Product Change Notification

Change Notification #: 112978 - 01
Change Title: Intel® Server System P4216IP4LHJC
PCN 112978-01, Product Design
Update the Mini-SAS Cable and
Preinstall the eUSB SSD Stand-off
Reason for Revision: Correct TA #

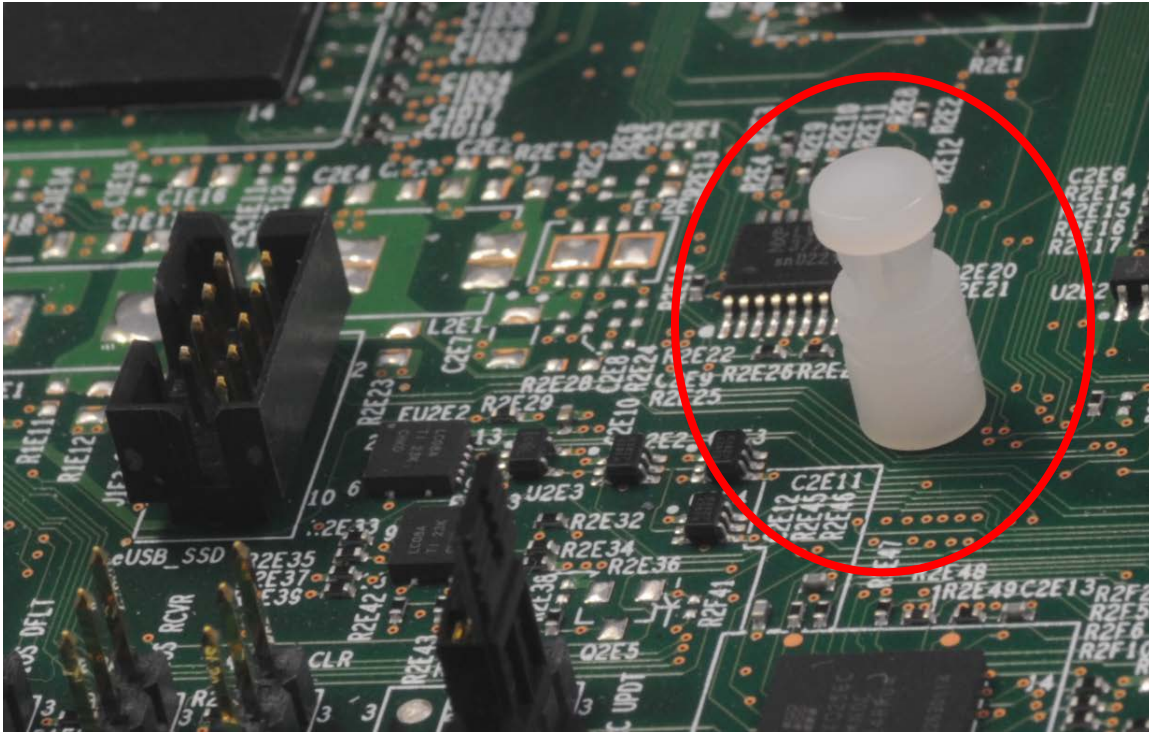
1. The Mini-SAS Cable length is being updated from 650mm (AXXCBL650MSMS) to 730mm (AXXCBL730MSMS) for a better connection between the PCIe-based RAID cards and the backplane, depicted below:
